---

**Customer: PRINCETON PLASMA PHYSICS LAB**

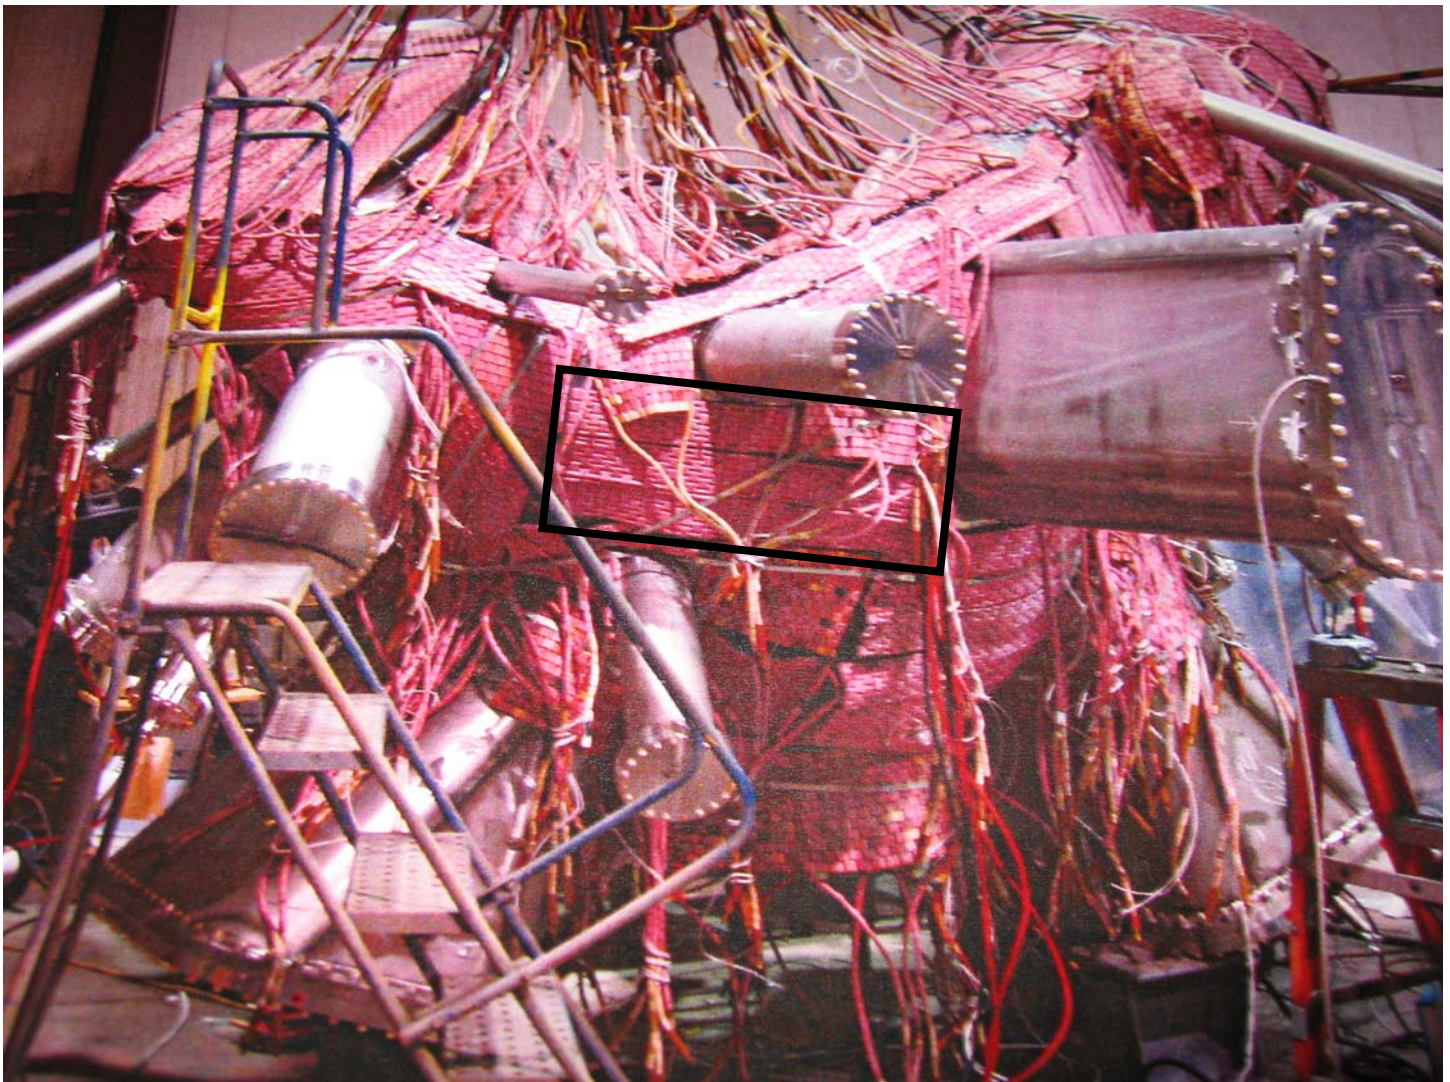
Photo added by M. Viola for clarification (Note boxed region of 3 pads):
